Subject: AP1000 COL Response to Request for Additional Information (TR #54)

Westinghouse is submitting a revised response to NRC request for additional information (RAI) on AP1000 Standard Combined License Technical Report 54, APP-GW-GLR-033, Rev. 0, Spent Fuel Racks Design and Structural Analysis. This RAI response is submitted in support of the AP1000 Design Certification Amendment Application (Docket No. 52-006). The information included in the responses is generic and is expected to apply to all COL applications referencing the AP1000 Design Certification and the AP1000 Design Certification Amendment Application.

RAI Response Number: RAI-TR54-08  
Revision: 1

Figure TR54-8.1 LSDYNA Model of Pool Liner and Rack Pedestal Bearing

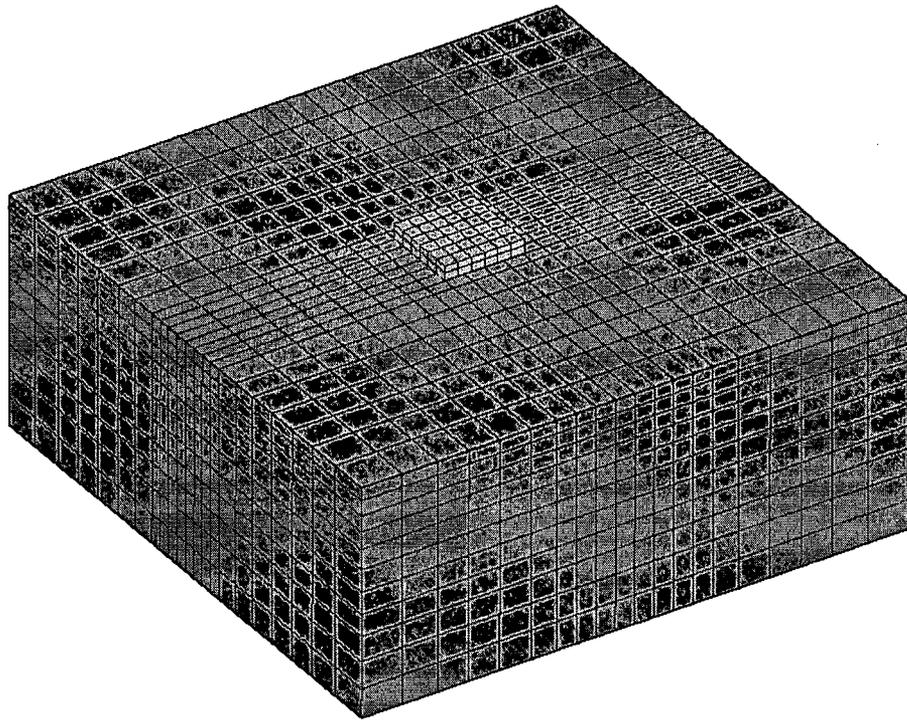
For the drop case in which the impact occurs directly above a rack pedestal, Section 2.8.5 provides the concrete strength of the pool floor and the thickness of the stainless steel liner, but does not provide the thickness of the pool floor. There is a possibility that the impact could also cause damage to the concrete floor, and pose a more severe consequence than yield of the liner. The maximum Von Mises stress in the spent fuel pool liner is reported as 23.4 ksi, which is much larger than the concrete strength of 4 ksi; the concrete may crush and crack locally at this level of stress. Therefore, provide additional details on the modeling of the concrete floor (including a figure of the concrete model, element type, boundary conditions, material properties, etc.) and the analysis results for the concrete floor (in addition to Figure 2-11).

October 8-12, 2007 Audit "The staff still needs confirmation that the concrete compressive strength in NUREG/CR-6608 is 4,000 psi.

The spent fuel pool concrete floor is modeled only in the vicinity of the impacted rack pedestal with an assumed thickness of two feet and compressive strength of 4,000 psi. The pool liner and rack pedestal bearing pad are also modeled as shown in Figure TR54-8.1. The periphery surface nodes of the SFP pool liner and the underlying concrete slab in the LSDYNA model are restrained from moving in the vertical direction and in the horizontal direction normal to the periphery surface to simulate the confining effect of the surrounding structure.
